ALTITUDE HOTEL & RESIDENCES

Downtown DRB
Design Recommendation Meeting No. 1

DPD# 3018037
August 16, 2016

PEDESTRIAN SAFETY

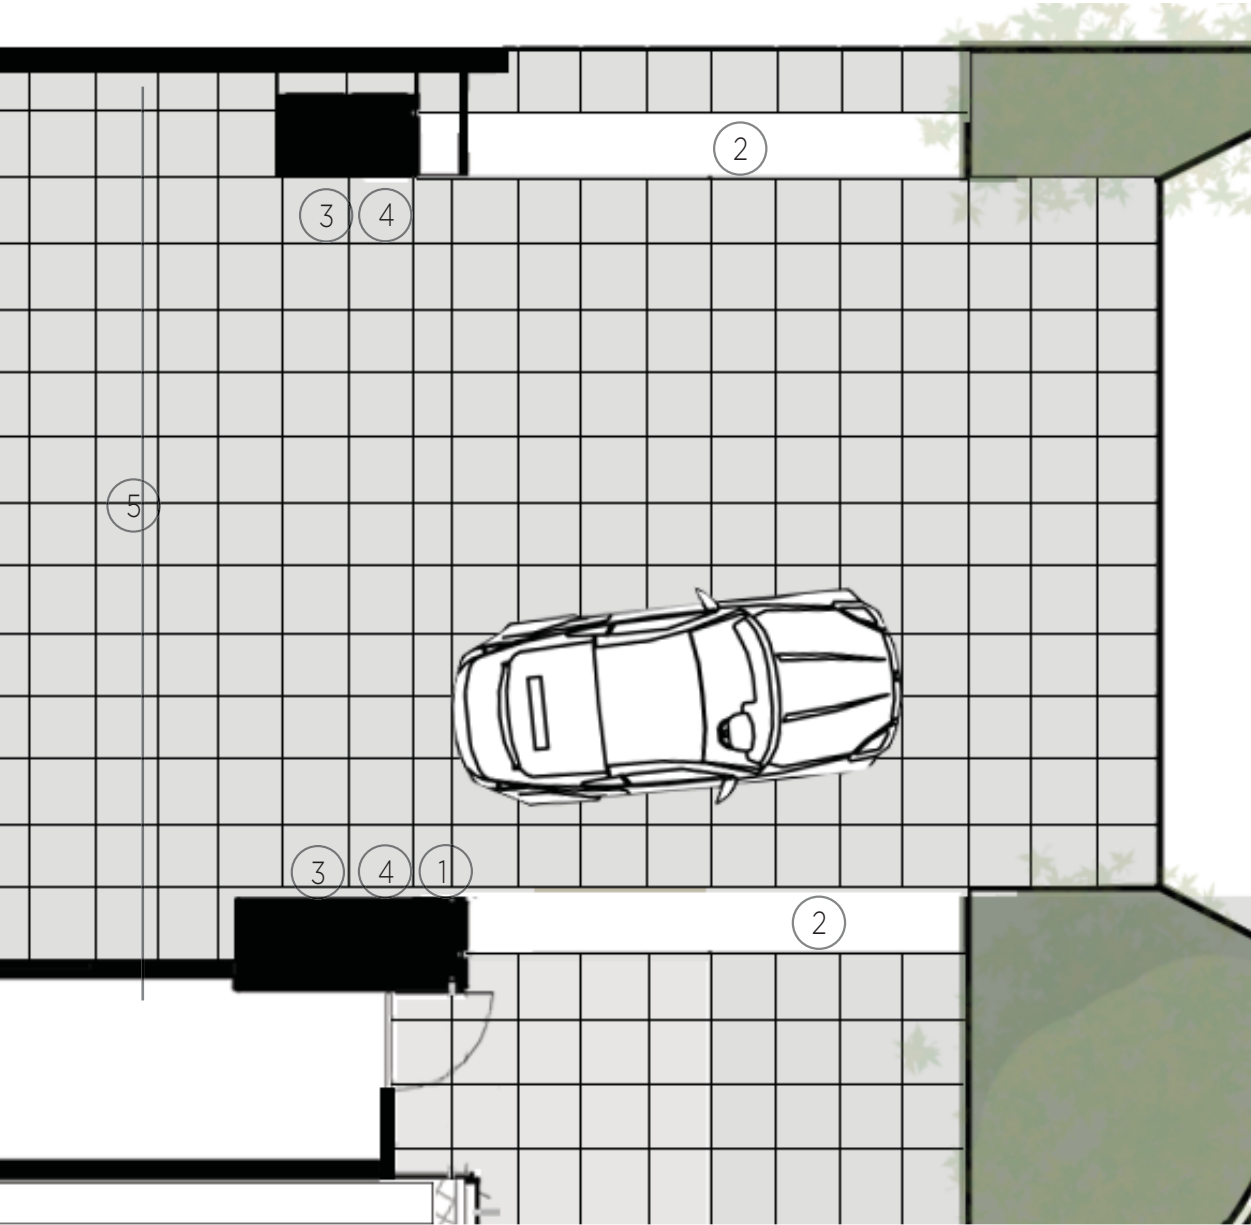
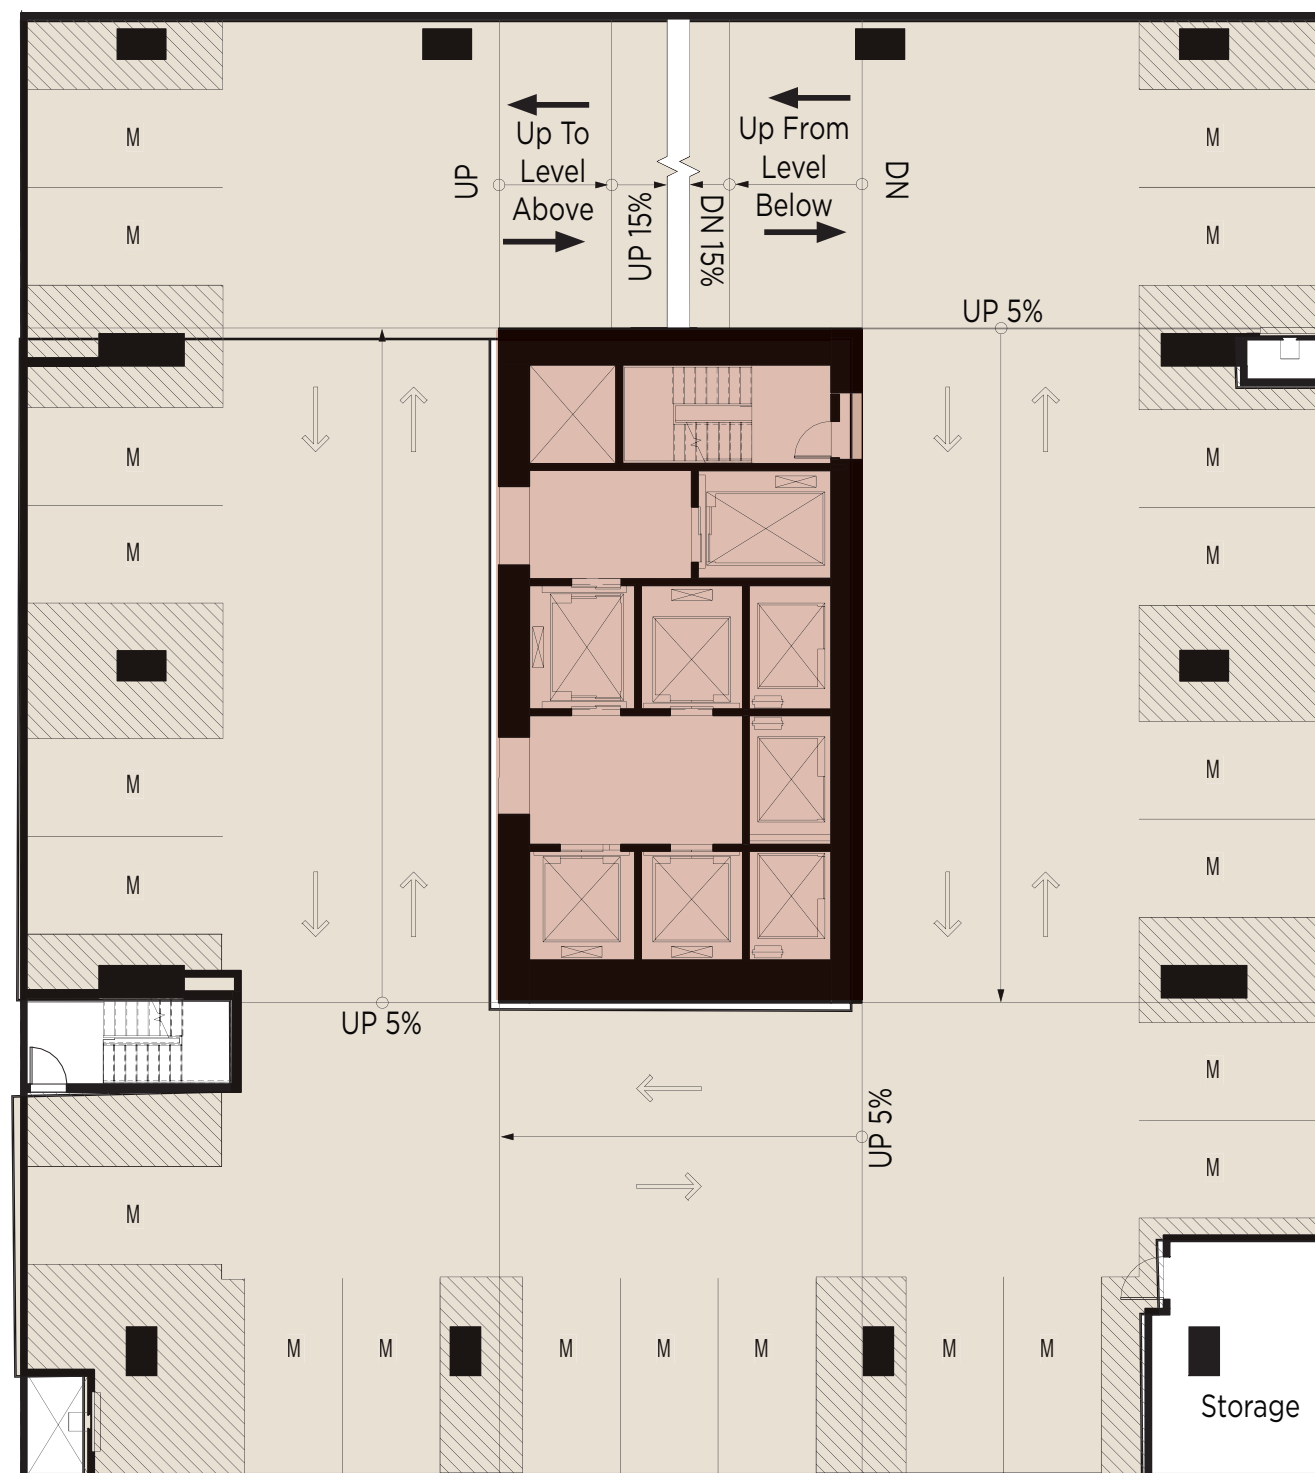
COMMENTS ADDRESSED:
EDG3 - #9 Additional information is needed regarding a streetscape plan that presents a developed design solution to pedestrian safety concerns & addresses the curb cut & parking entry on 5th Ave

1. Domed Mirror
Installed above entry to ensure full visibility from all angles

2. Truncated Dome Tactile Warning
Located @ each end of garage entry to provide warning for the visually impaired

3. Security Camera
Installed at each side of the parking entry

4. Pedestrian Alert Safety Sign
Installed at each side of garage entry with full verbal warning & activated flashing lights when a car enters its proximity

5. Rolling Gate Overhead Door
Located past entry to ensure safety within parking garage

6th Floor - Outdoor Residential Amenity

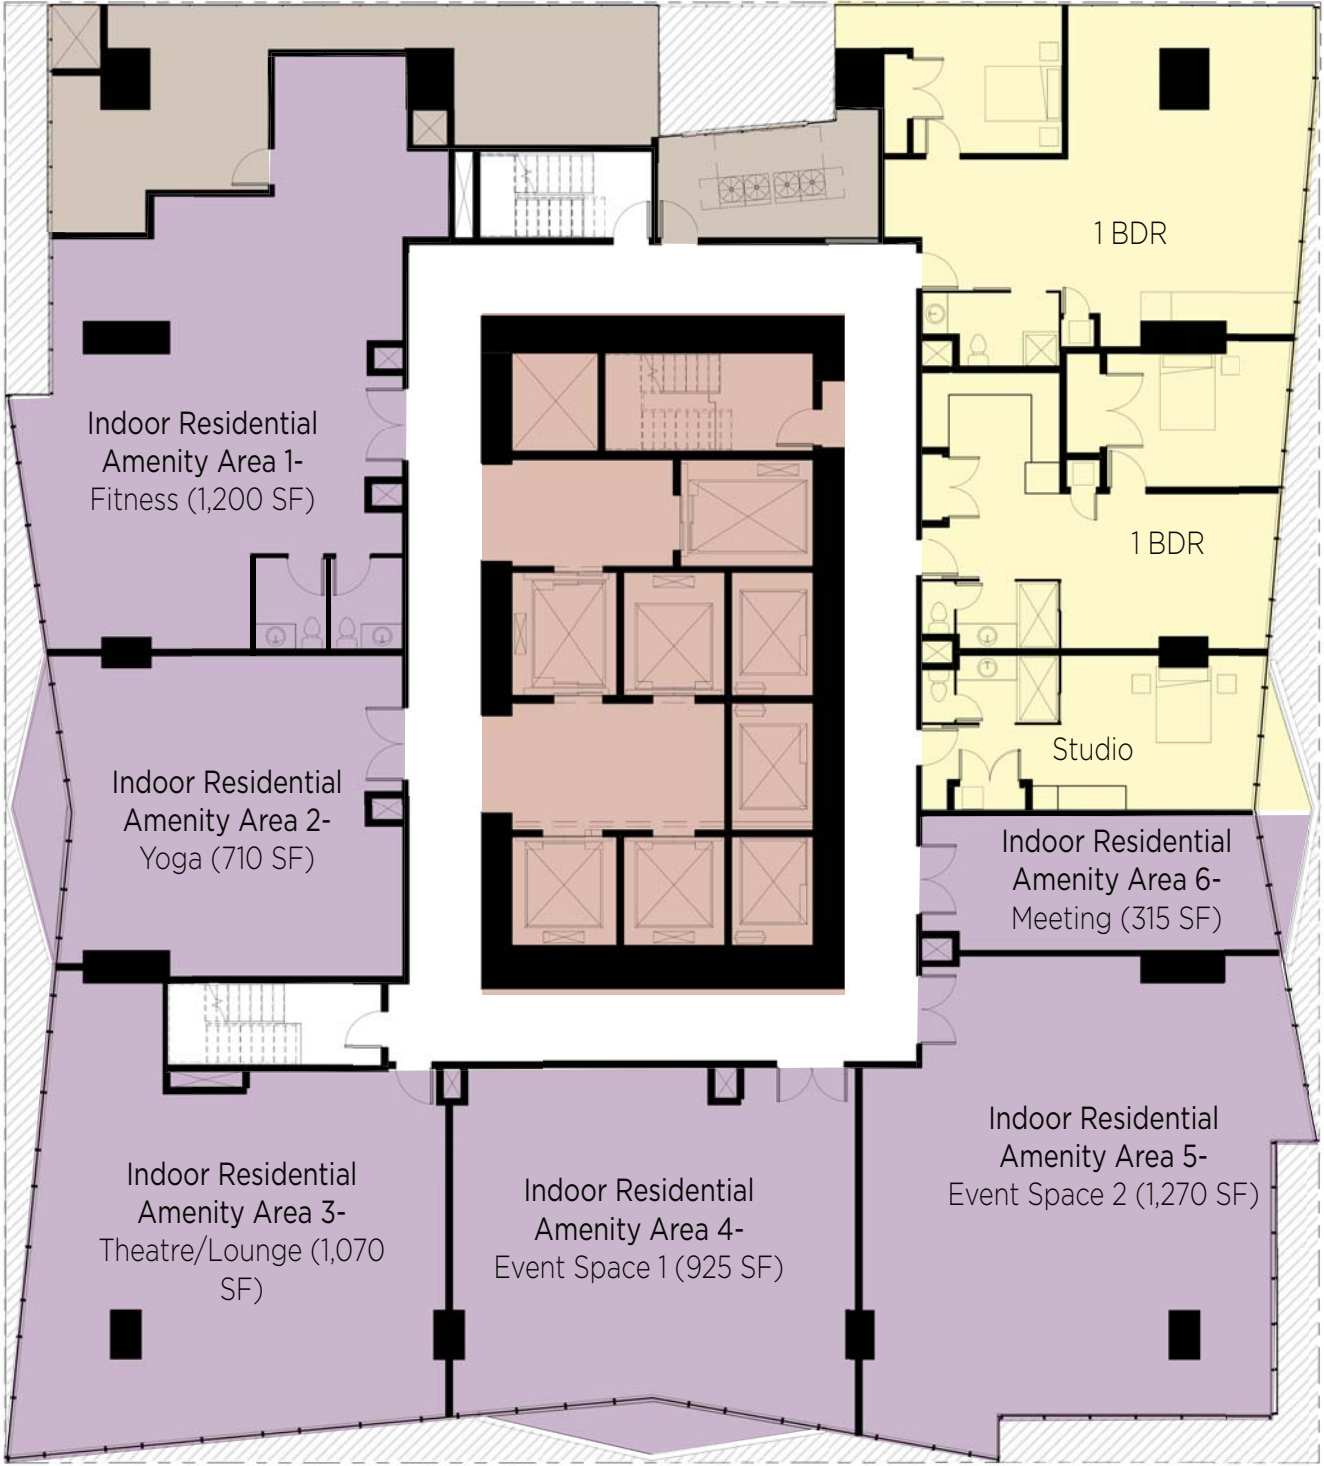
COMMENTS ADDRESSED:
LU - #1 *Include the nature of the individual amenities to be provided in the amenity areas*

7th Floor - Indoor Residential Amenity

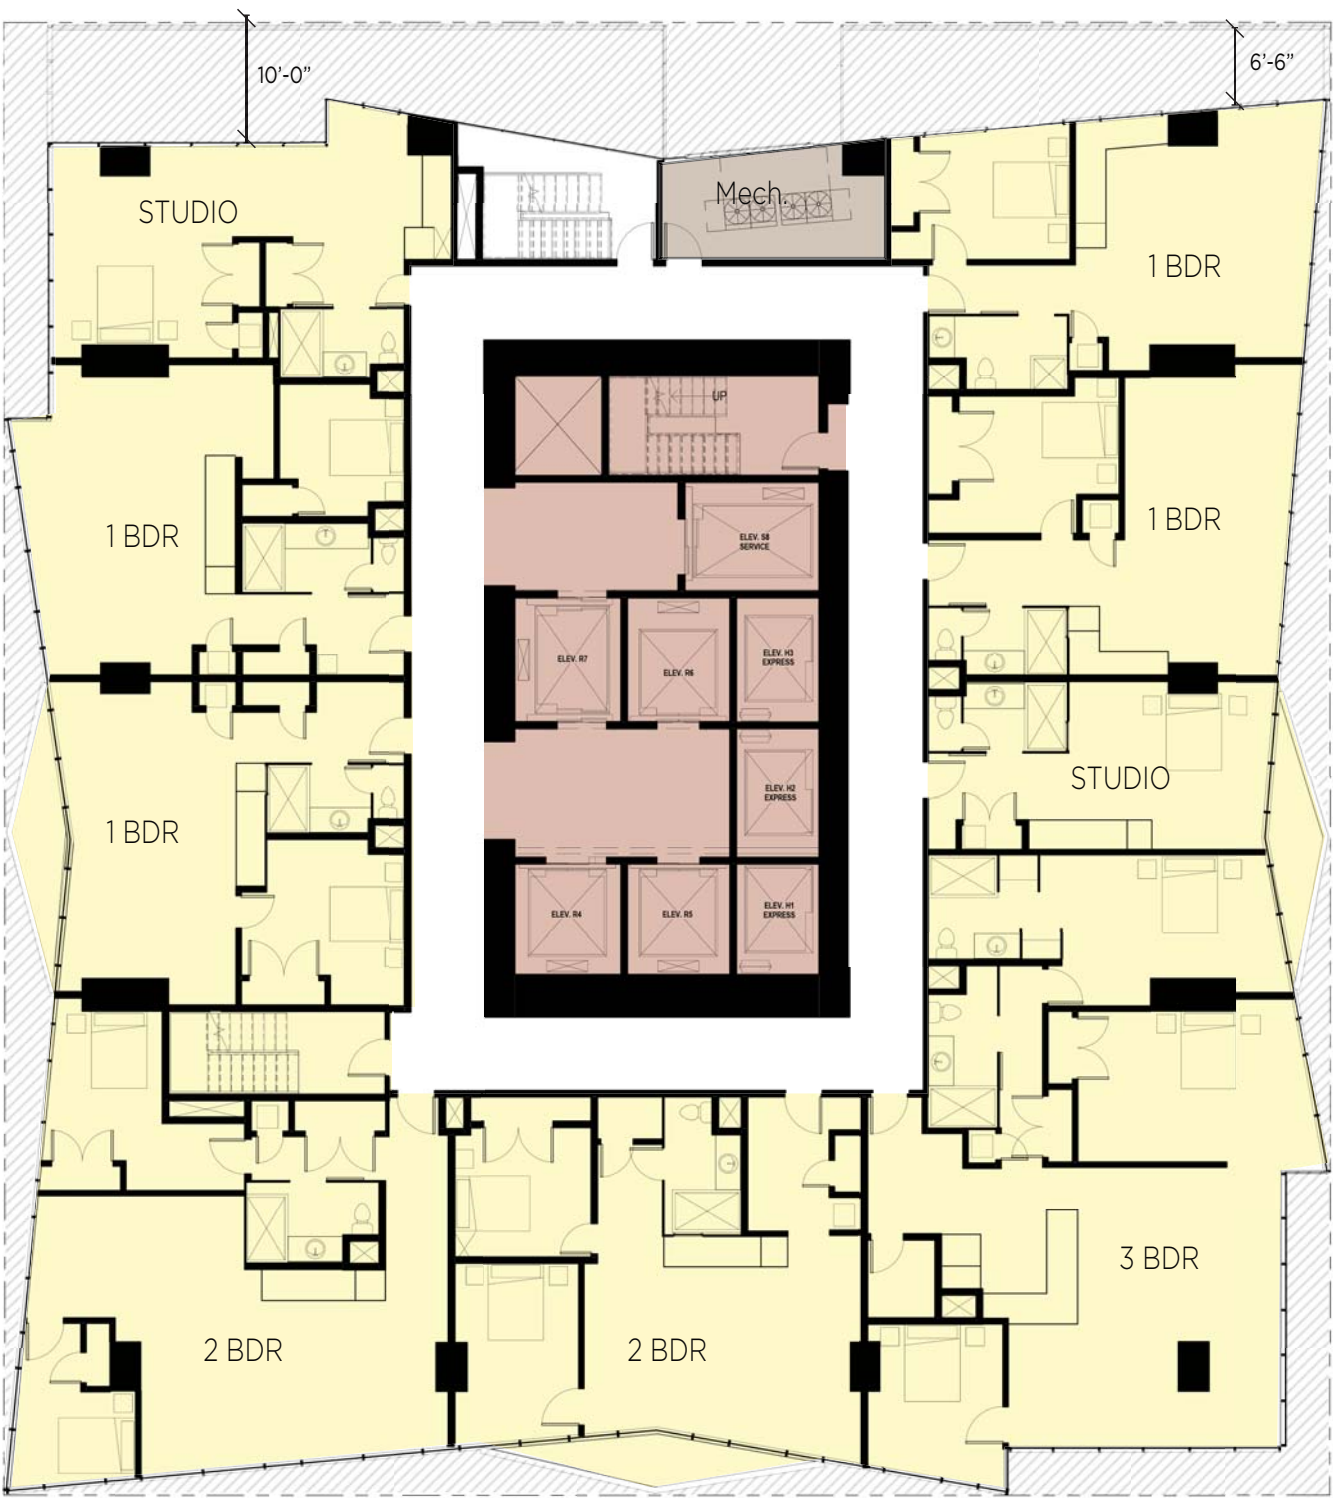
COMMENTS ADDRESSED:
LU - #1 *Include the nature of the individual amenities to be provided in the amenity areas*

- MEP Space
- Residential Amenity Area
- Residential
- Allowable Floor Area Not Used (875 Square Feet)
